BEFORE THE HISTORIC LANDMARKS COMMISSION OF THE CITY OF ASTORIA

STAFF REPORT AND FINDINGS OF FACT

NEW CONSTRUCTION REQUEST (NC21-01) TO CONSTRUCT ONE

BUILDING AT 432 W MARINE DRIVE AND ONE AT 65 PORTWAY STREET

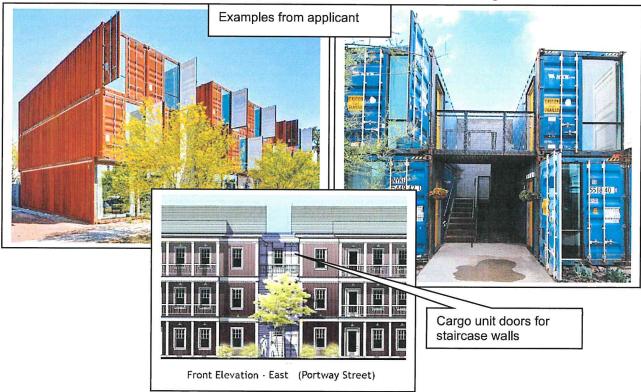
Pod 2 would be surrounded by the industrial Port area. To the west is the train repair Quonset hut of corrugated metal, and onestory former State Police office building. To the south across Industry and the River Trail is Bergerson Construction with corrugated steel one and 1.5 story shop and three-story board and batten office building. To the northeast is a one and 1.5 story industrial building with a mixture of horizontal siding and board and batten, and the two-story Astoria River Walk motel. The City finds that this area along Portway and Industry Streets is very industrial and the use of exposed, painted CorTen steel cargo containers for the siding would be compatible with this neighborhood. The City also finds that the elevation difference and adjacency to the rear of the historic building and its parking lot lessen the impact of the proposed building on the historic structure and its historic West Marine Drive streetscape. Therefore, the City finds that the siding is compatible with the historic structure.

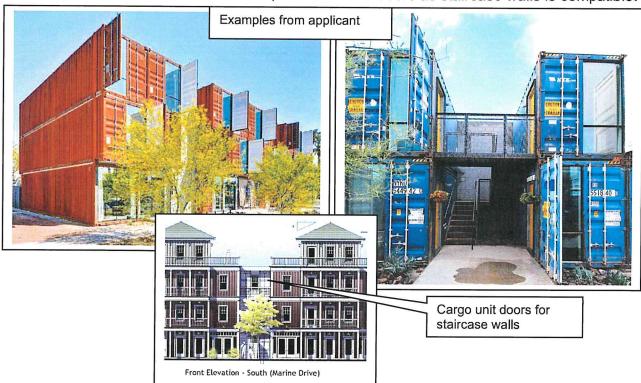
Section 14.158.F.1 of the UTO prohibits the use of corrugated metal as siding. While this is a City Code applicable to this project, it is not part of the HLC's criteria and therefore, not applicable to the HLC review. The Design Review Commission will consider this Section in their review of Design Review Request (DR21-01). Due to the fact that the DRC may require a different siding than the CorTen steel, the HLC will allow use of either the CorTen steel as proposed, or a wood or fiber cement board and batten siding as an option. Therefore, the City finds that either the exposed, painted cargo units, or wood or fiber cement board and batten siding are compatible with the historic streetscape (Condition 4). If fiber cement material is used, it shall be smooth and not textured (Condition 1).

The walls of the central staircase would be the cargo container unit doors with existing cargo door locking hardware remaining. The doors would retain their utilitarian design, however, unlike the photo examples provided by the applicant, they would be painted to match or complement the main structure and therefore, the "shipping" information printed on the doors would not remain. With the design of the cargo container units for the main part of the structure, the use of the cargo doors would be compatible with the design of the structure. Therefore, the City finds that if the doors are painted to match and/or complement the main structure color removing any shipping information (Condition 2), that due to the location, the use of the doors as staircase walls is compatible.

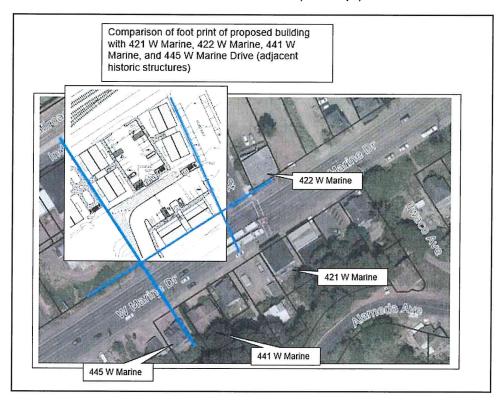
If the design is changed to a board and batten style siding, the use of the cargo container doors would not be compatible with the building itself. If the siding is board and batten, the central staircase walls shall not be uncovered cargo doors and shall be vertical or horizontal wood or fiber cement siding painted to match or complement the siding color or be constructed of some other design reviewed and approved by the Planner to differentiate it from the mass of the two separate parts of the Pod (Condition 5).

Therefore, the City finds that if the siding is changed to board and batten and the doors are covered and/or a wood or fiber cement siding used and painted to match and/or complement the main

structure color (Condition 5), the staircase walls would be compatible.

Appearance without pop-up

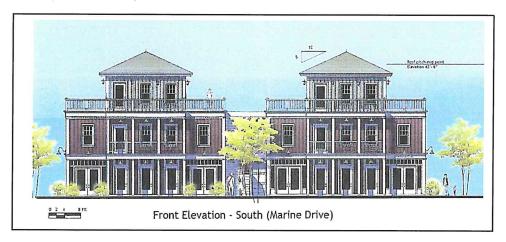
The flat roof height is 30' and the pop-up brings it to 42.5' high. The applicant has indicated that he could eliminate the pop-up feature but that he wanted it to provide variety to the architecture of the building. As noted above, several of the historic residences to the west across the W Marine Drive right-of-way, which are not adjacent but are visible in the streetscape from this site, are three stories tall. However, the historic criteria of Section 6.070.B.1. specifically requires that ". . . The design of the proposed structure is compatible with the design of adjacent historic structures considering scale, style, height, architectural detail and materials." The proposed three stories with a flat roof at 30' is higher than the height of the adjacent historic structures. It would be one story (10') higher than Portway and approximately one story (approximately 5' to 10') higher than 421 W Marine. With the additional mass of the building at 70% larger than the adjacent structures, the height difference increases the impact of the scale of the building.

With the elimination of the pop-up, the City finds that the overall height / scale of the building is still higher and more massive than the adjacent historic structures.

As noted above, the historic review is for compatibility with the "adjacent historic" structures. If the building were reduced to two floors with or without the pop-up, the height / scale of the building would be compatible with the historic structures. Therefore, based on the above discussion, the City finds that the building shall be reduced to two floors with or without the pop-up (Condition 6).

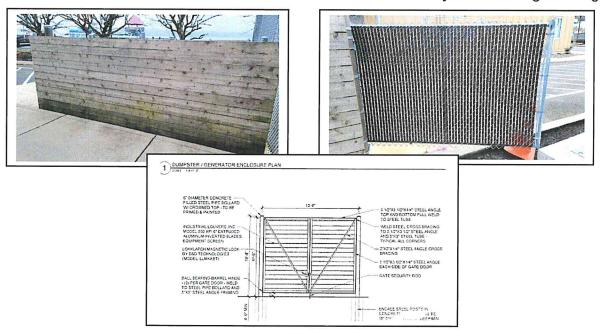
Section 14.152.C.2, Uniontown Overlay (UTO), Development Standards, Stepback, Additional Building Height, states "Where the height of a building or building addition is proposed to exceed

35 feet, at least that portion of the building exceeding 28 feet or two stories, whichever is less, shall provide a stepback of at least 10 feet from the plane of the proposed building or building addition that faces the right-of-way or River Trail (see Figure 14.152.-3)." Pod 1 would be 30' tall at three stories and would require a 10' stepback for any portion of the building above 28' or two stories (whichever is less) to allow the height to 42.5' with the pop-up. The pop-up is stepped back, but the height of the facade of the building is 30' and three stories. The height at two stories is 20'. Therefore, to exceed 35', the third floor of the building (20' elevation between 2nd and 3rd floor) would need to be stepped back 10'. Pod 1 does not comply with this stepback requirement and the applicant would be required to obtain a variance if this height is approved by the HLC. This code section is not part of the HLC review criteria but will be considered by the DRC for Design Review Request (DR21-01). However, with the elimination of the third floor, the building height would be in compliance with the UTO requirements and with the historic compatibility with adjacent historic structures.

Based on the height of other buildings in the neighborhood, the high visibility of the structure, and the requirement for a stepback, the City finds that the height of the three-story building would not be compatible with the historic streetscape and that the building shall be reduced to two floors with or without a pop-up (Condition 6).
